PLAN OF PROPOSED SUBDIVISION

OLD BULLI HOSPITAL

LANDSCAPE MASTERPLAN

LOT 1 DP326181, LOT 1 DP83742, LOT 1 DP595930,
LOT 1 to 8 DP7677 & LOT 19 to 22 DP6793
LANDCOM - OLD BULLI HOSPITAL
27-29 HOSPITAL ROAD, BULLI
PROPOSED SUBDIVISION - DA CIVIL DRAWINGS

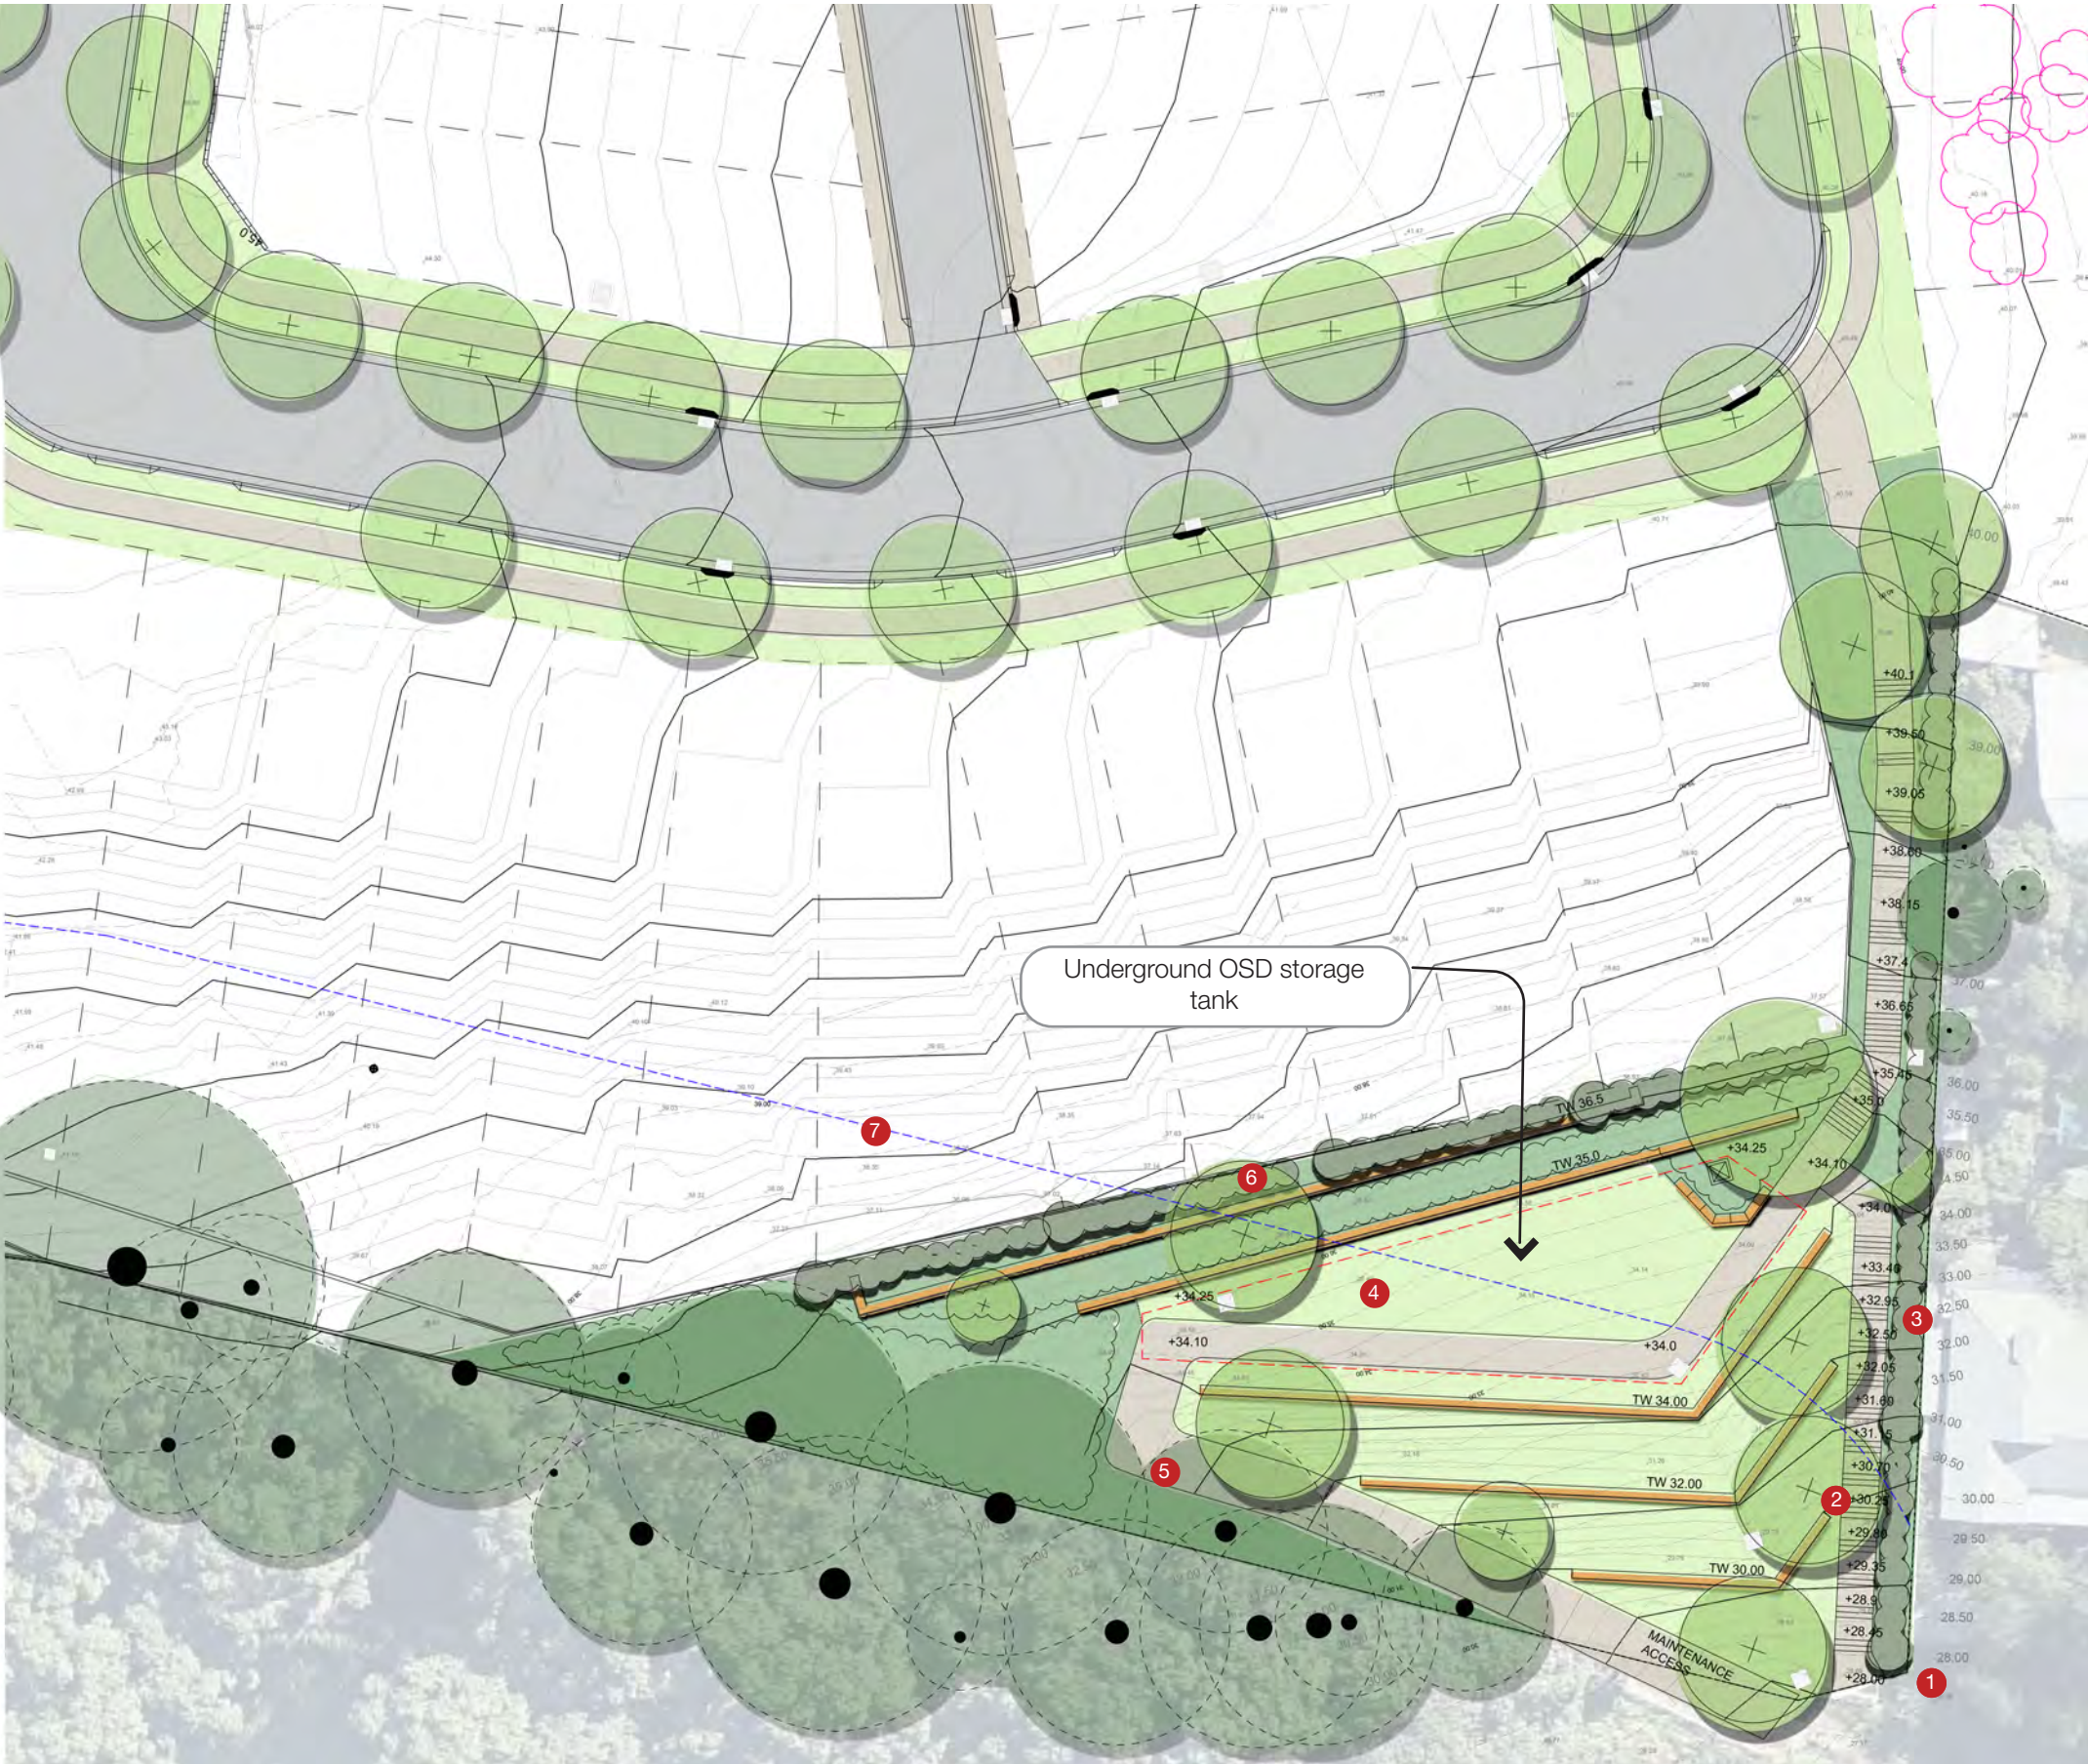
LIST OF CHANGES
04.04.2025– Nature play, accessible ramps and viewing deck removed as instructed by Wollongong City Council

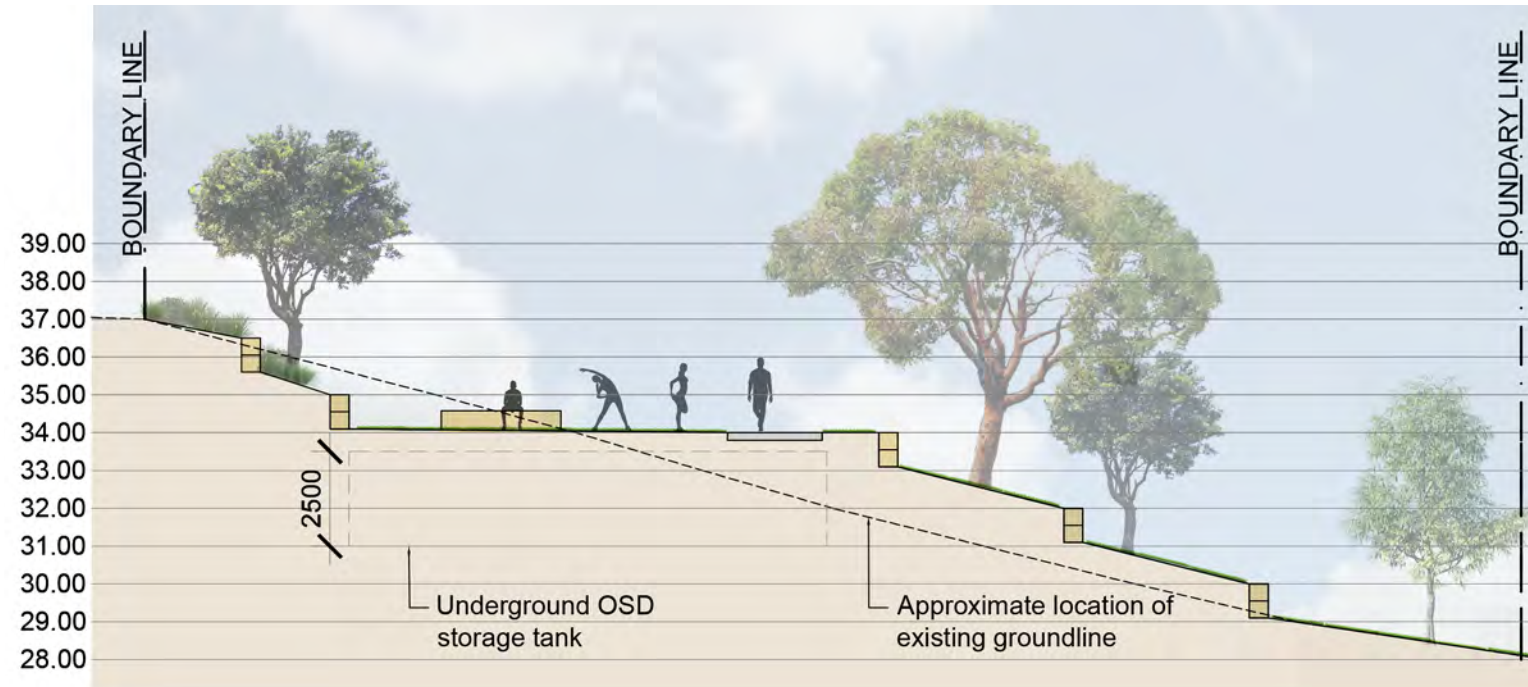
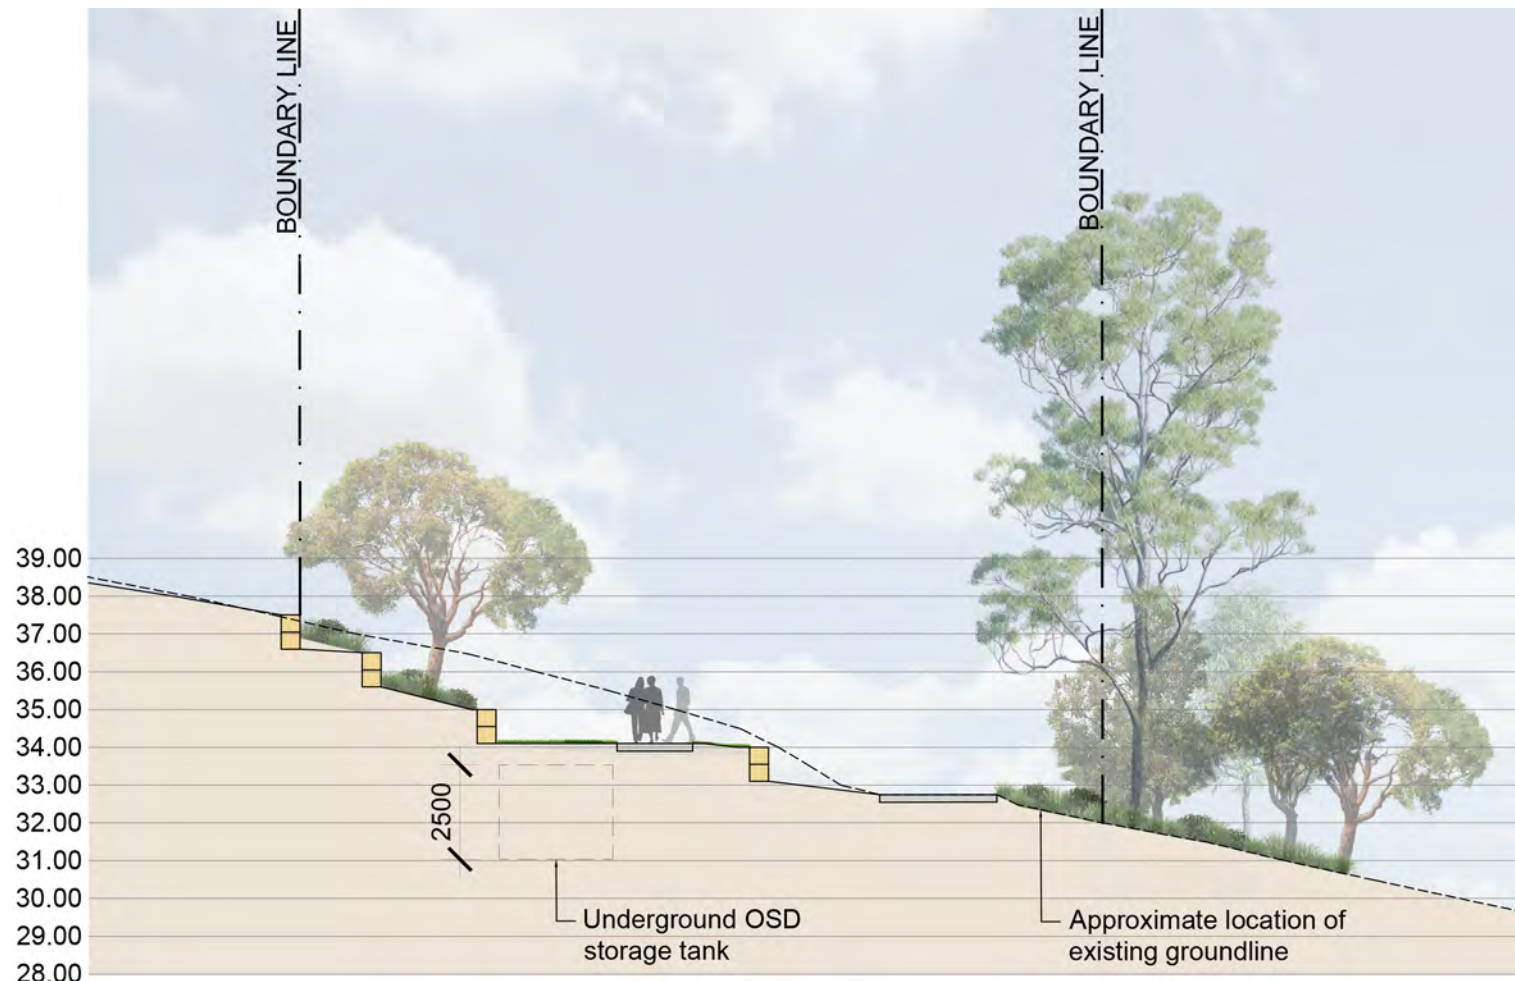
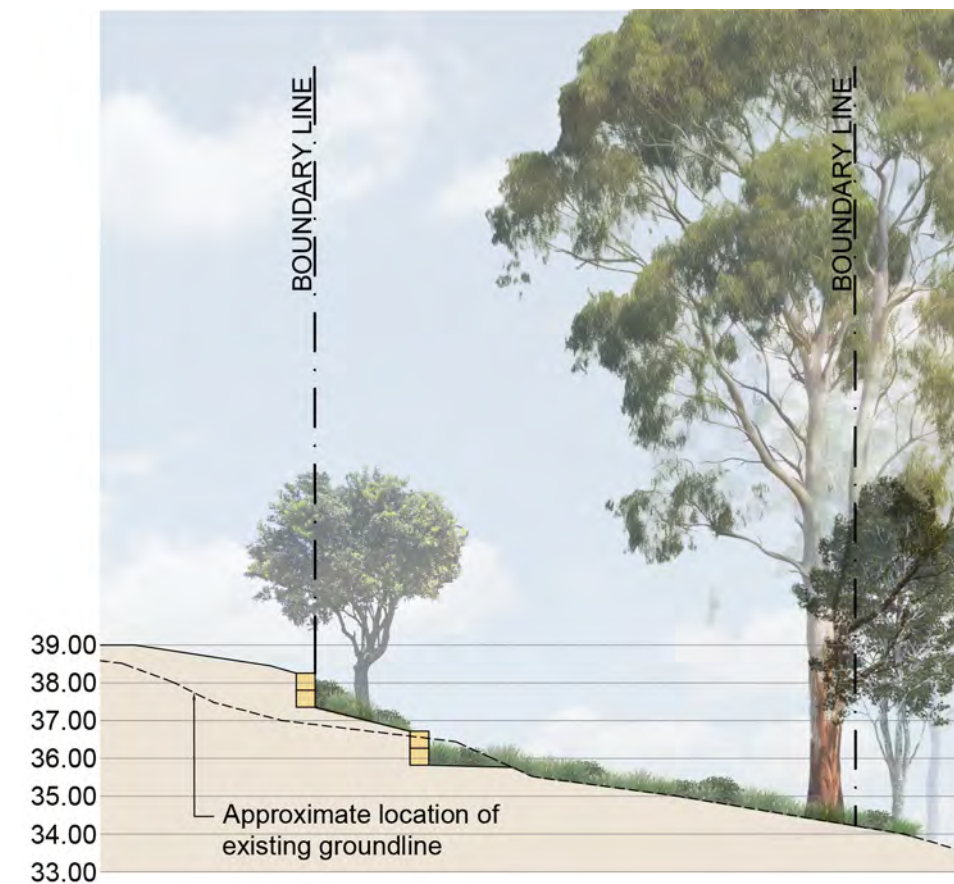
LIST OF CHANGES
04.04.2025 – Southern open space updated to remove planting between retaining walls. Grass slopes are shown with a max 1:4 grade as requested by Wollongong City Council
